**MANDATORY BULLETIN No. SportStar-043a SR R1  
SAFETY RELATED**

- 1. CONCERNING:** All SportStar airplanes.
- 2. REASON:** Unification of the strength class of the fastening bolts in the joint of the engine and the engine mount hinges and the resulting minimization of the possibility that these bolts will be accidentally interchanged.
- 3. REQUIRED ACTIONS:**
  1. Replace the fastening bolts in accordance with the bulletin text.
  2. Record the replacement in the Aircraft Logbook.
- 4. LATEST DAY OF THE ACTION:** Within 30 calendar days of the issue of this bulletin or during the next scheduled service inspection, whichever occurs first.
- 5. CARRIED OUT BY:** Organizations authorized for maintenance / repairs of this type of airplane.
- 6. COSTS COVERED BY:** Airplane owner/operator.
- 7. NECESSARY MATERIAL:** In accordance with the bulletin text.
- 8. WORK PROCEDURE:** In accordance with the bulletin text.
- 9. APPENDICES:** None.

Valid from: June 28nd, 2023

*Fig. 1 – Securing the engine against falling*

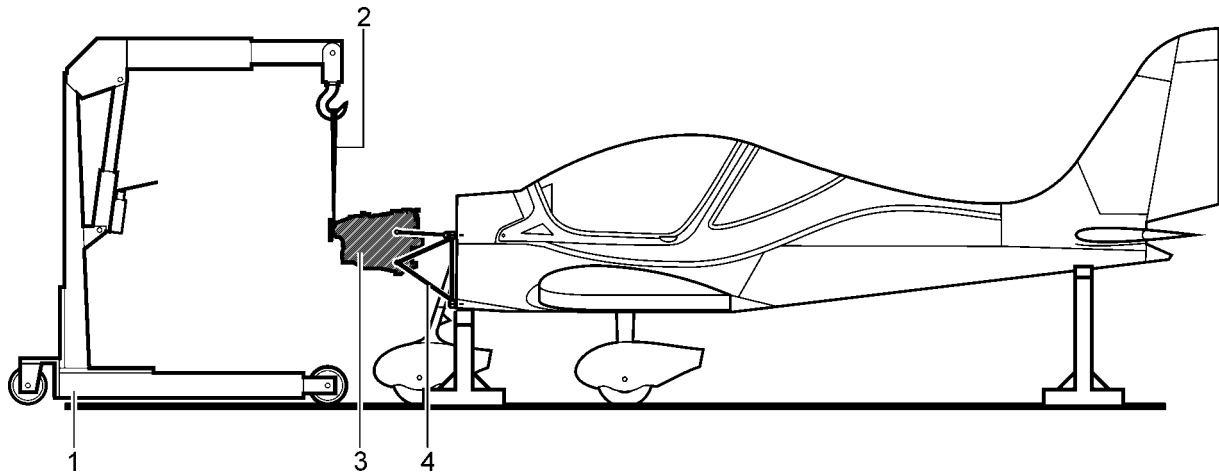
- 1.3.1.8 Secure the ends of the removed hoses with suitable plugs against the ingress of dirt.
- 1.3.1.9 Hang the engine (3, Fig. 1) on the workshop crane (1) using the suspension strap (2). The engine (3) is now secured against falling.
- 1.3.1.10 Remove the cotter pins and plugs (5, 7, Fig. 3) from the bolts (1, 2, 3, 4, Fig. 2) in the joint of the engine and the engine mount hinges.

- 1.3.1.21 Release the engine from the mounting crane (Fig. 1).
- 1.3.1.22 Remove all plugs from hoses or devices.
- 1.3.1.23 Attach all hoses which were previously removed to gain access to the bolts.

Fig. 2 – Engine mount – position of fastening bolts

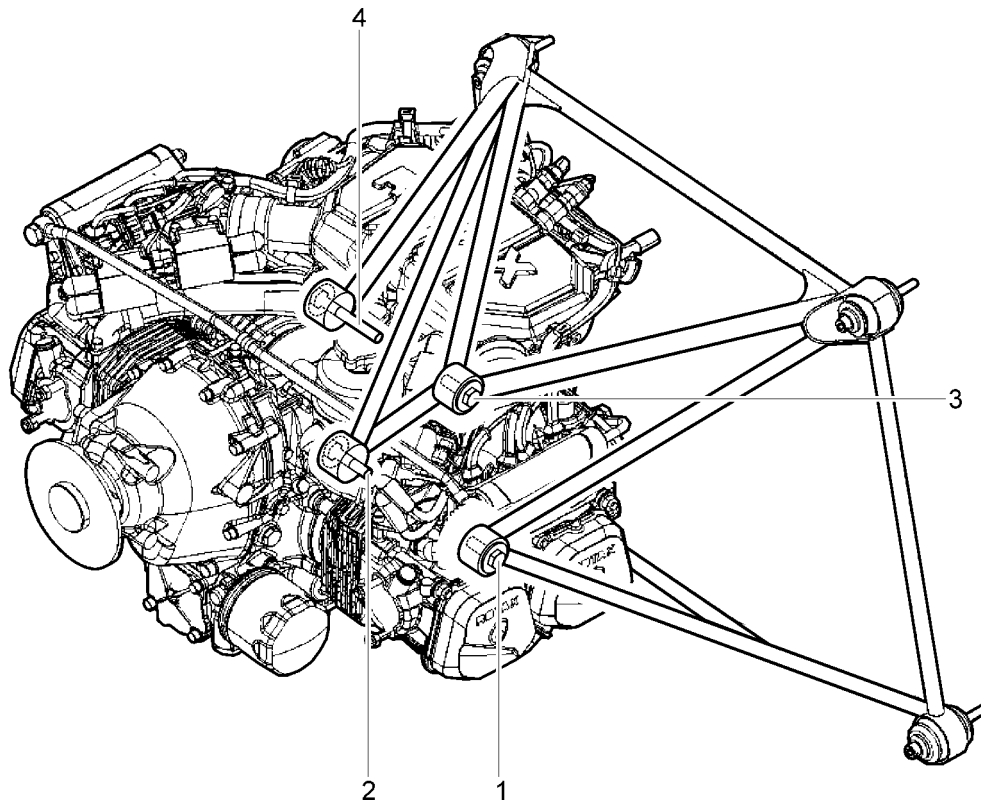
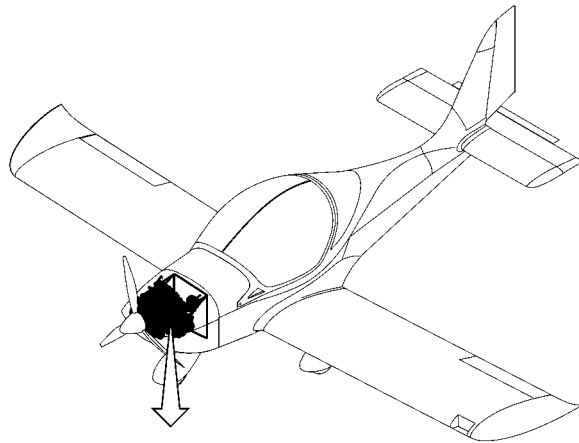
- 1.3.1.11 Remove the bolt (1) from the joint of the engine and the engine mount hinges. Immediately replace the removed bolt with a new one and tighten it slightly.

- 1.3.1.12 Remove the bolt (2) from the joint of the engine and the engine mount hinges. Immediately replace the removed bolt with a new one and tighten it slightly.

- 1.3.1.13 Remove the bolt (3) from the joint of the engine and the engine mount hinges. Immediately replace the removed bolt with a new one and tighten it slightly.

- 1.3.1.14 Tighten the bolt (4) in the joint of the engine and the engine mount hinges using a torque wrench with a torque of 40 Nm. This bolt is the only one that is not replaced, but the tightening torque value is changed from 35 Nm to 40 Nm.

- 1.3.1.15 Tighten the bolts (1,2,3) in the joint of the engine and the engine mount hinges using a torque wrench with a torque of 40Nm.
- 1.3.1.16 Put the plugs (5, Fig.3) on the bolts (4), (1,2,3,4, Fig.2).

Fig. 3 – Engine suspension

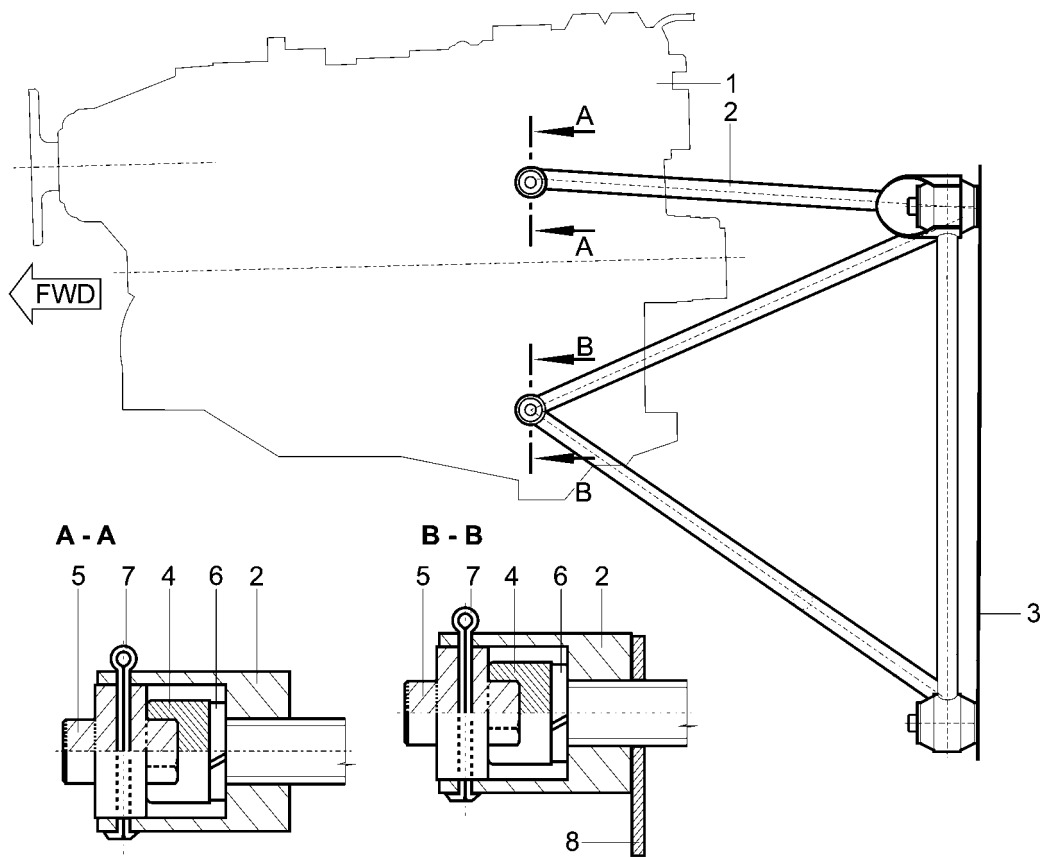
- 1.3.1.17 Mark the plugs (5, Fig. 3) with a marking pin in accordance with the holes in the engine mount hinges (2) on both sides.
- 1.3.1.18 Remove the plugs (5) from the bolts (4) and drill through them with a  $\varnothing 2,1$  mm drill bit in accordance with the marks made by the marking pin.

- 1.3.1.19 Put the plugs (5) back on the bolts (4) so that they align with the holes in the engine mount hinges (2).
- 1.3.1.20 Use the cotter pins (7) to secure the bolts (4) with the plugs (5) in the joint of the engine and the engine mount hinges (2).

- 1.3.1.26 Refill the operating fluids (coolant, oil) according to the ROTAX Maintenance Manual MML-912 | PART NO.: 899196 or later if they have been drained while accessing the bolts of the engine mount hinges (4, Fig. 3).
